# **ROCK CREEK WRRF PRIMARY CLARIFIER No. 4 TREATMENT EXPANSION CLEAN WATER SERVICES**

## **SECTION 17050**

**BASIC MEASUREMENT AND CONTROL INSTRUMENTATION  
MATERIALS AND METHODS**

RESPONSE TO SUBMITTAL COMMENTS

## LOOP DRAWING INDEX

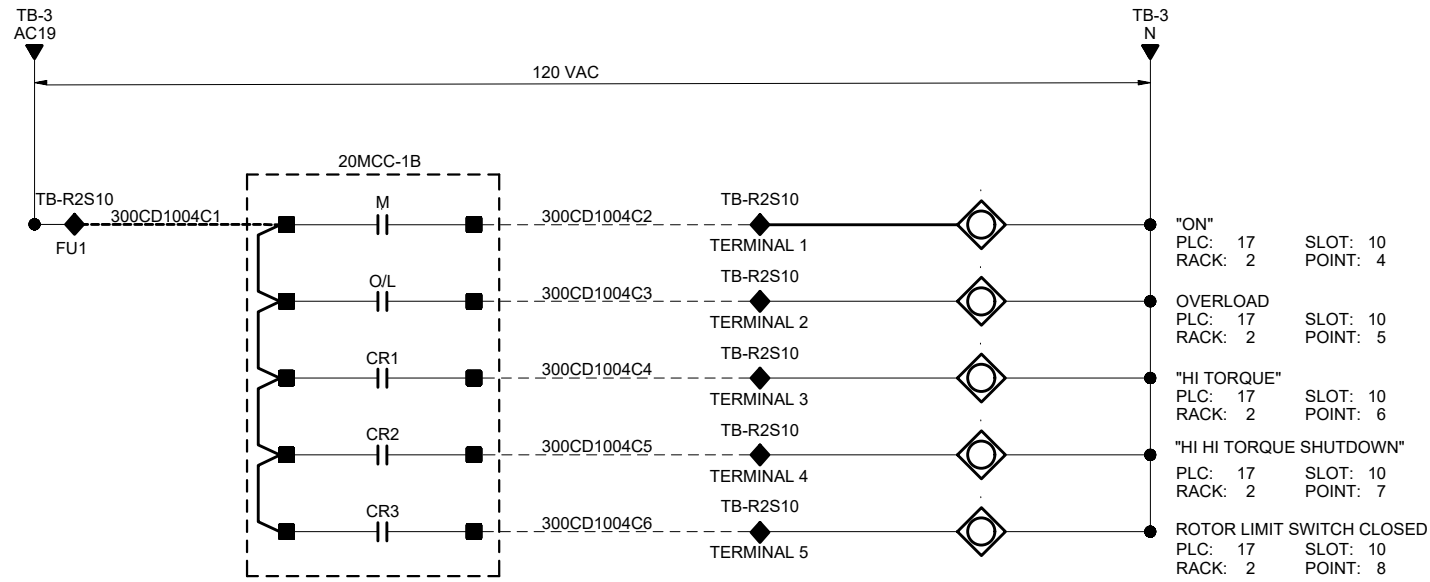
Add a loop drawing index/ table of contents in table format to include sheet number, drawing number, description.

*Amended.*

SHEET TITLE: INSTRUMENTATION CLARIFIER DRIVE LIMIT SWITCH LOOP DRAWING

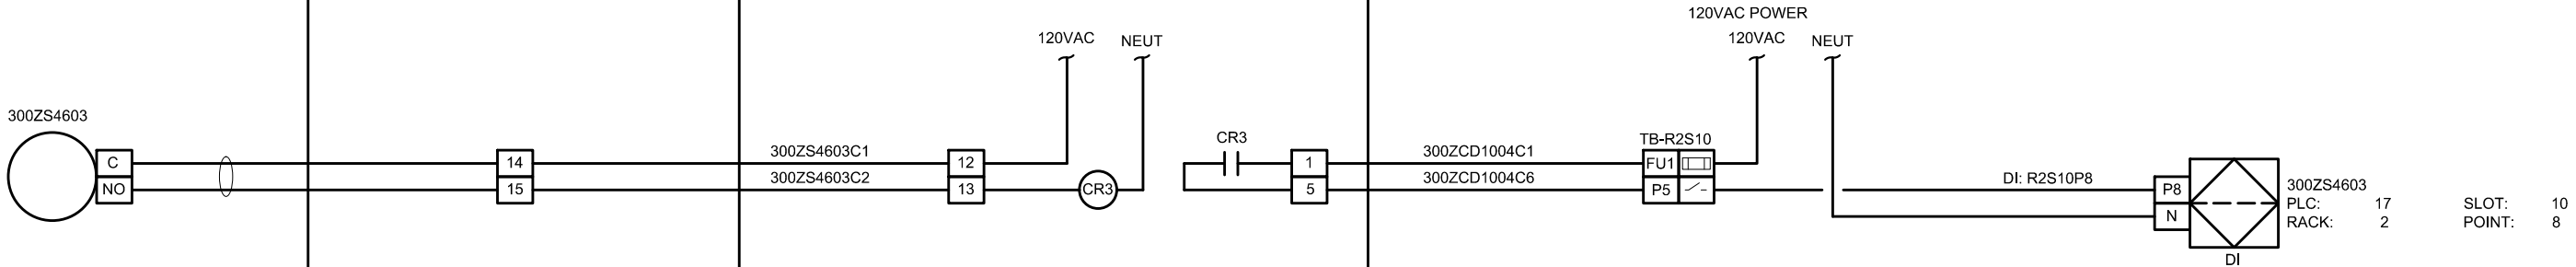
MCN-PR – Missing Loop Diagram for Clarifier Drive Limit Switch, 300ZS4603. Make sure that this is included in the final submittal.

*Amended.*

SHEET TITLE: INSTRUMENTATION  
PRIMARY SCUM PUMP 3  
BOTTOM COUNTER  
LOOP DRAWING

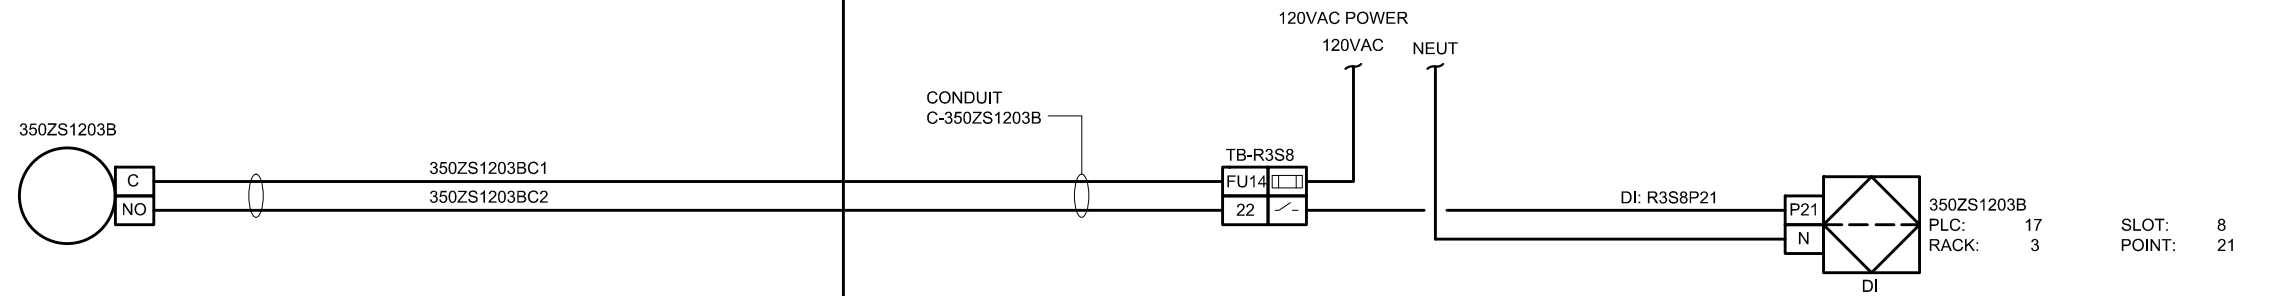
Sheet 18: label all LCS terminals (missing one NSHH terminal)

*Amended.*

SHEET TITLE: INSTRUMENTATION PRIMARY SLUDGE PUMP 5 VFD CONTROL DIAGRAM

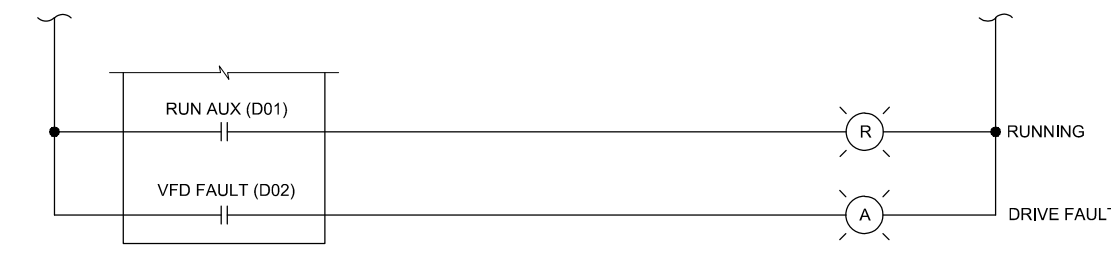
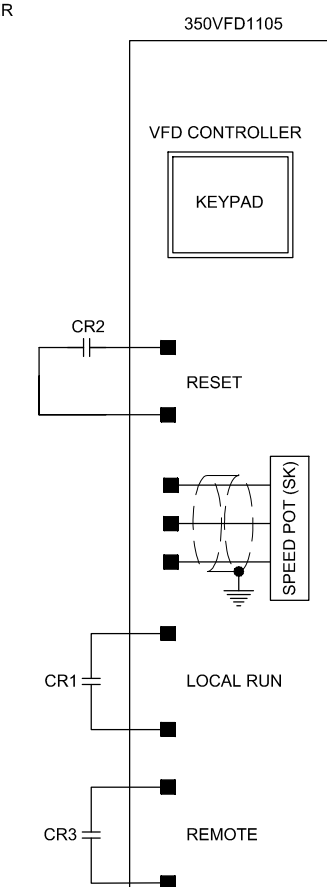
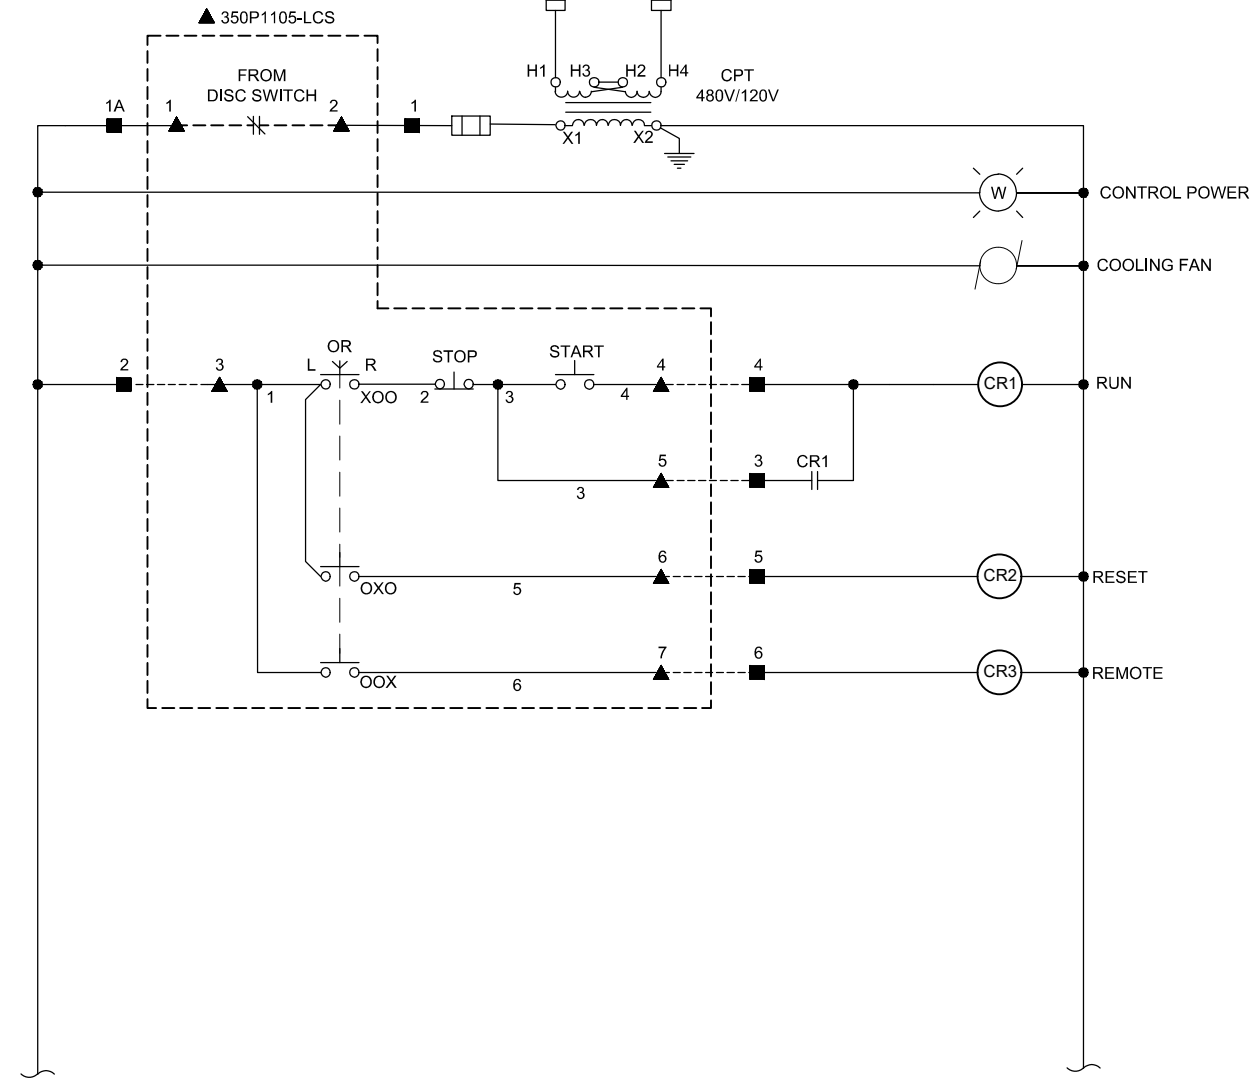
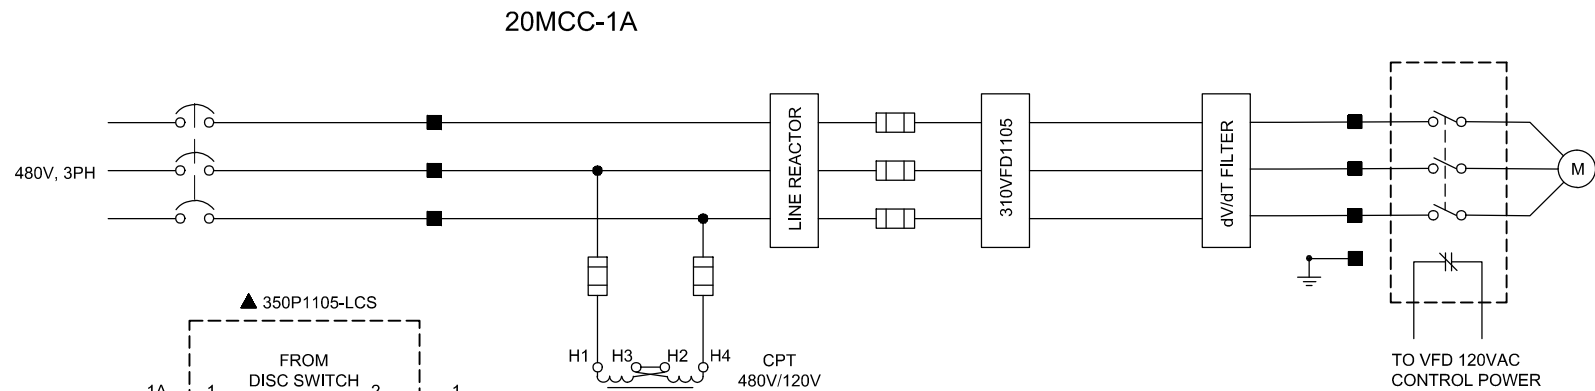
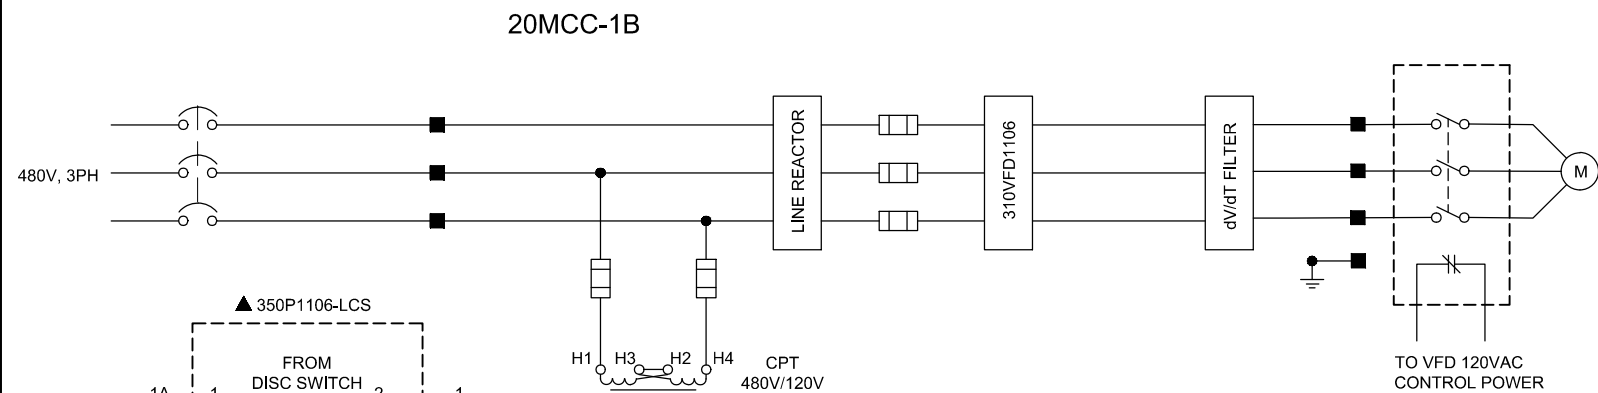
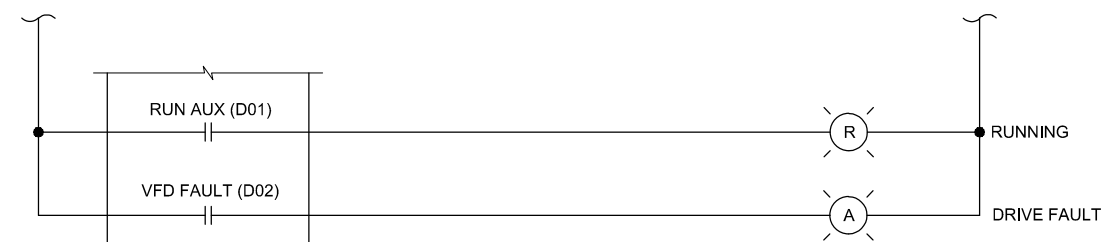
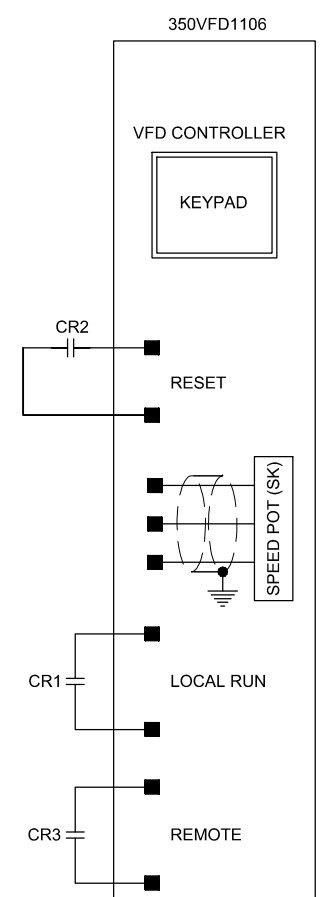
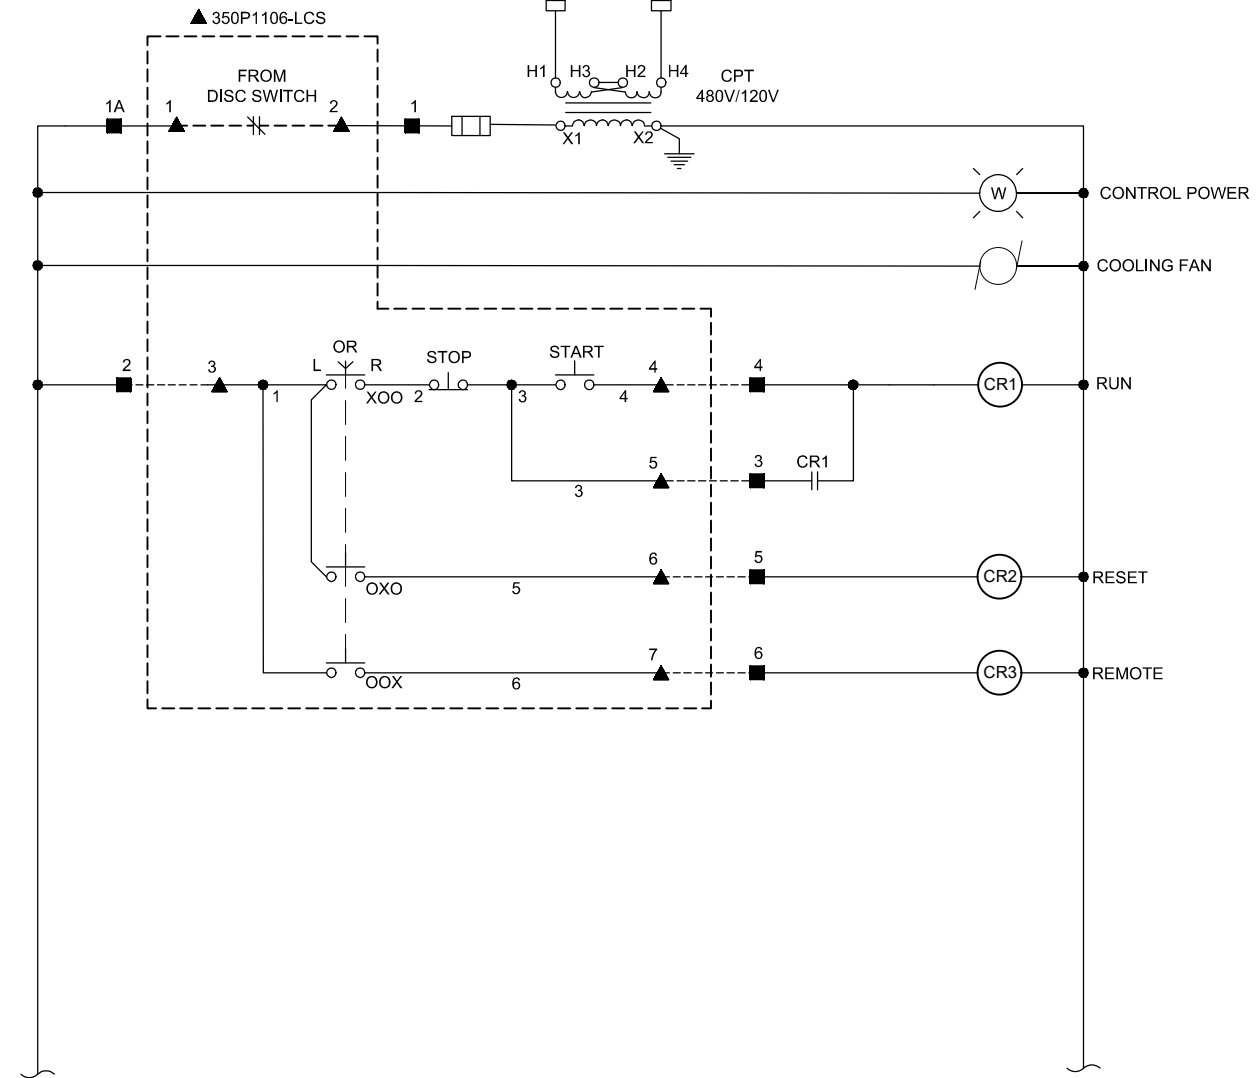
MCN-PR – The Loop Diagrams for Primary Sludge Pump 5 VFD and Primary Sludge Pump 6 VFD (350P01105, 350P01106) are different. It is my understanding that they should be the same. Explain if the differences are intentional. If the differences are accidental, resubmit the corrected Loop Diagram.

*Amended.*

MCN-PR – The STOP pushbutton was moved from being located before the LOR switch as shown in the design drawings to being after the LOCAL cam switch of the LOR. Confirm with CWS that this modification is acceptable.

*Change was made in response to Kurt's initial comments: "Each Stop pushbutton needs to be located directly after the switch label XOO. Otherwise, between XOO symbol and the start lock in circuit that routes to CR1 contact and Start pushbutton" and is in accordance to Kurt's latest drawing markups, see example below.*

SHEET TITLE: INSTRUMENTATION  
 IRRIGATION BOOSTER PUMP  
 WIRING DIAGRAM

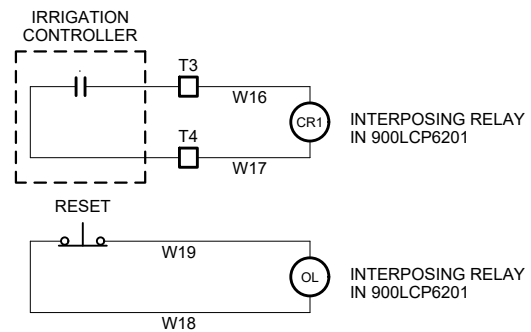
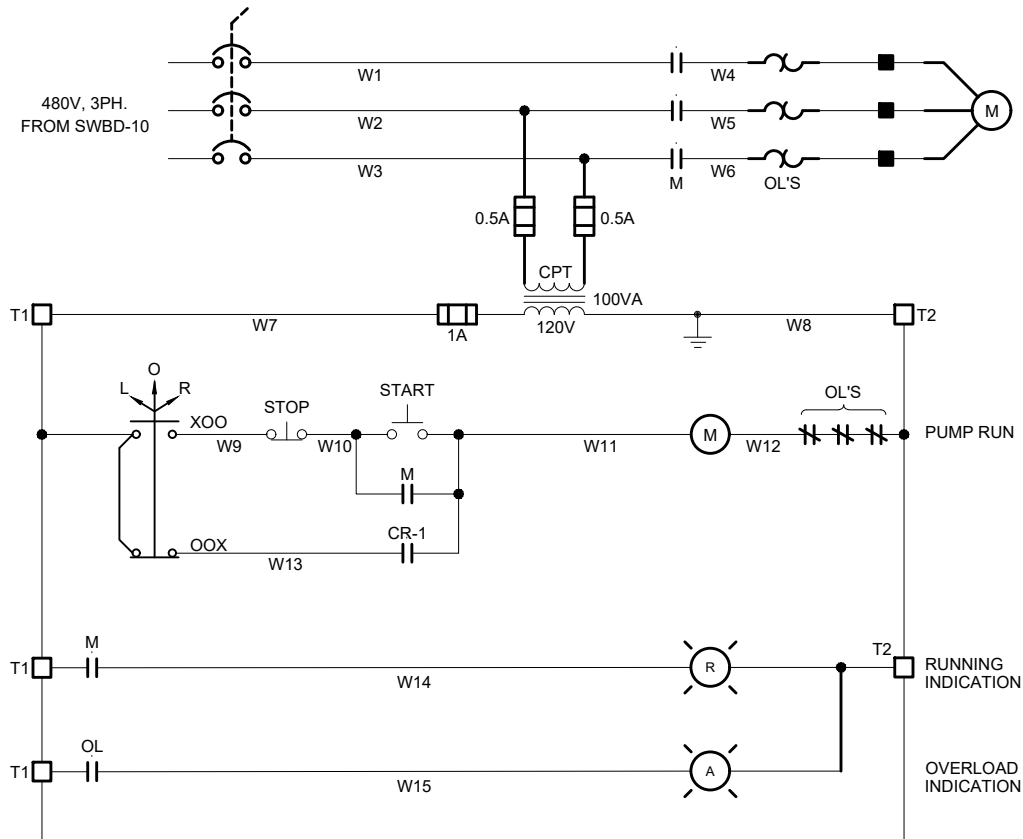
Add wire labels and terminal numbers on 900LCP6201.

*Amended.*
